Appln. No. 10/773,454  
Amtd. dated October 26, 2006  
Reply to Office Action of July 26, 2006

Amendments to the Drawings

**ANNOTATED DRAWING SHEET SHOWING CHANGES**

Fig. 1

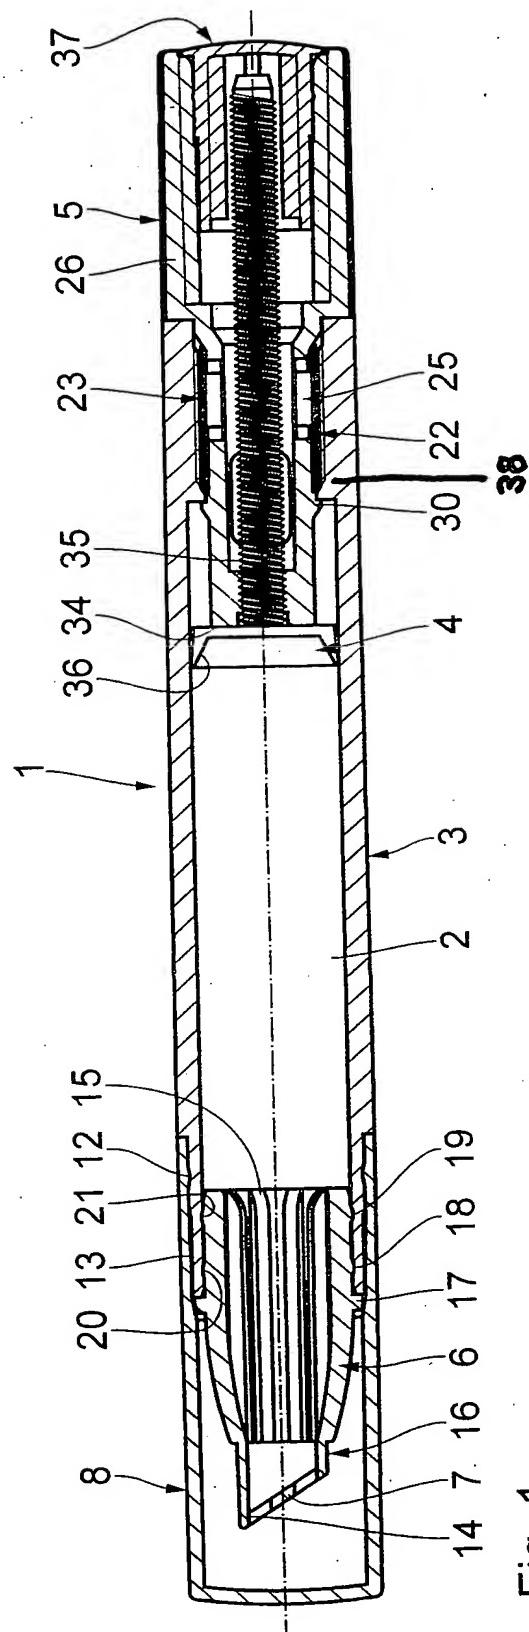
In Fig. 1, previously omitted element 38 has been identified.

Applicant notes that element 38 described in the drawings but not identified therein is set out in amended Fig. 1.
